Master Plan Amendment #2020-00009

CDD Concept Plan #2020-00007

Landmark Neighborhood – 5701, 5701B, 5801, 5815, 5901 Duke Street

Staff Recommendation: APPROVAL WITH CONDITIONS

Figure 12: Open Space

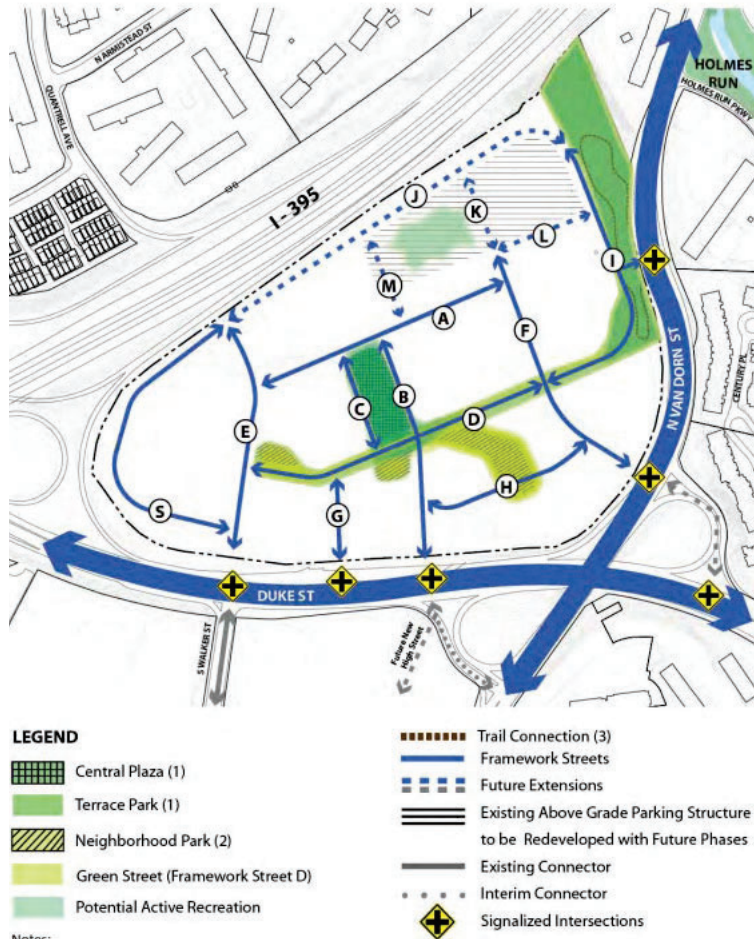
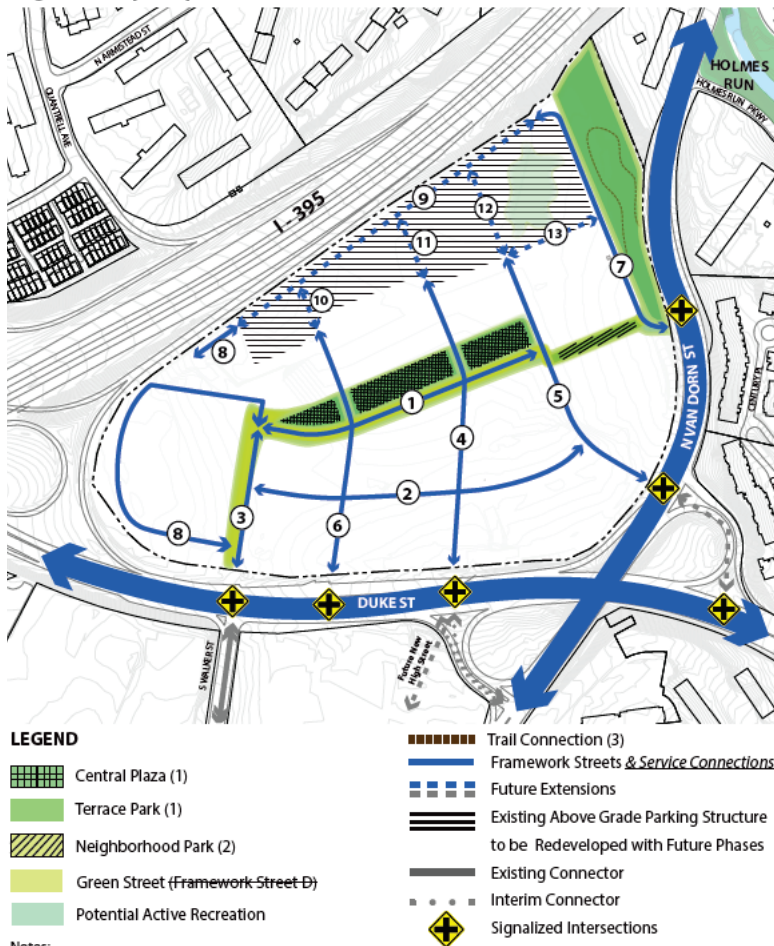
1. The Central Plaza and Terrace Park will be provided in locations depicted in Figure 12.
2. The locations and sizes of Neighborhood Parks, with the exception of the paseo between Streets 5 and 7, will be determined as part of the development review process.
3. Trail connection in Terrace Park is for illustrative purposes only.
4. In addition to the minimum 3.5 acres of publicly accessible open space, a minimum of 25% open space at-or above-grade is required per development block. A hospital campus, if provided, may provide less than 25% for the campus, as determined by the CDD.
5. Potential Active Recreation use can be provided to the extent parking is not needed.

Figure 15: Building Height

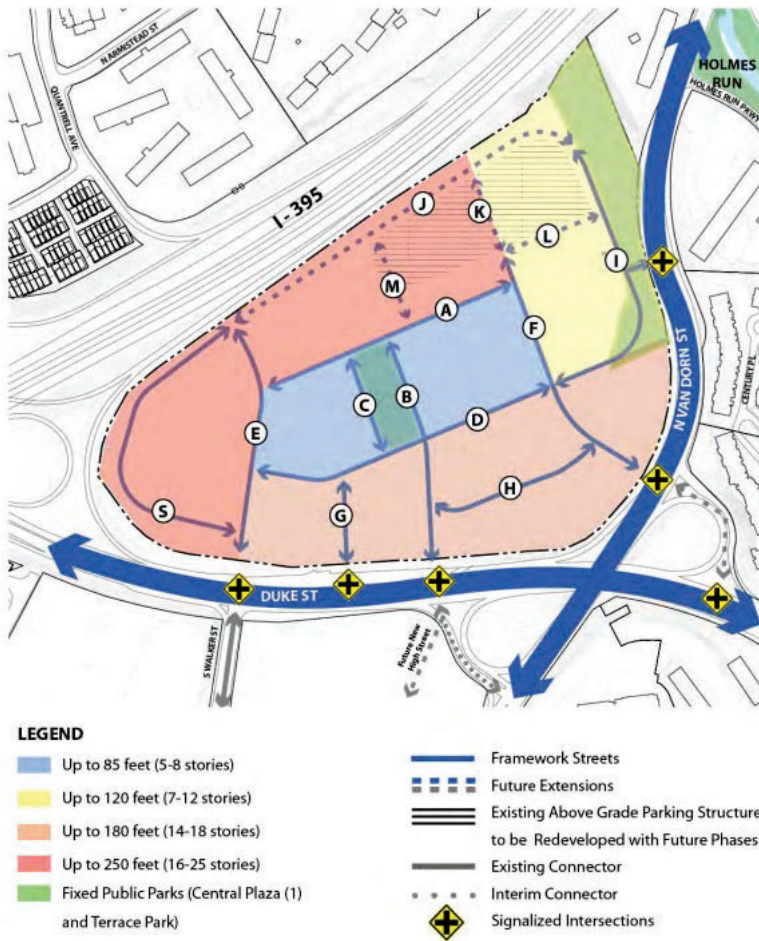
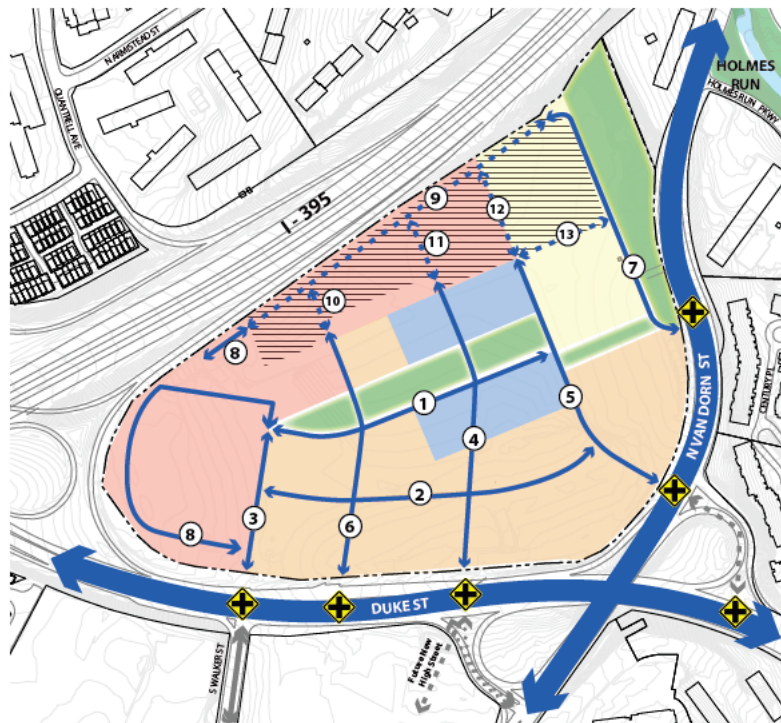
The applicant proposes to modify the Corridor Plan's building heights, as depicted below (Figure 7).
